Report to Sydney West Joint Regional Planning Panel

| JRPP No. | 2014SYW150DA |
| Proposed Development: | 6 x Residential Flat Buildings |
| Land/Address: | Lot 205 DP 660230, 822 Windsor Road, Rouse Hill |

Figure 7. Temporary access (Signature Property Group, 2014)

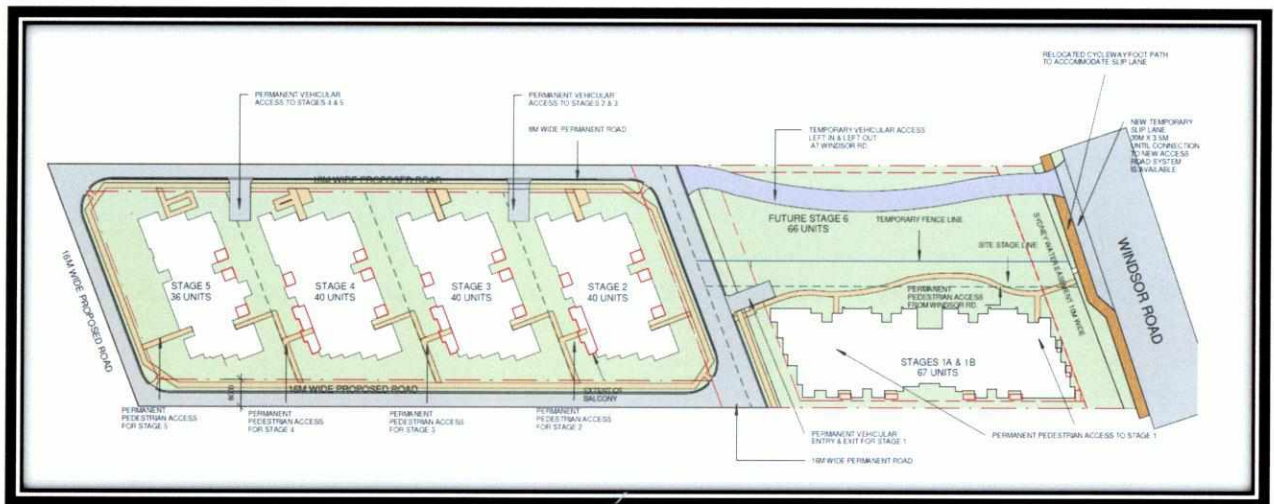
- 5.7 The DA proposes temporary access to Windsor Road through Stage 6 of the development until such time as the adjoining blocks have been developed and road access can be provided by the road pattern identified in the Area 20 Indicative Layout Plan. Figure 7 below demonstrates temporary access for Stages 1 to 5.
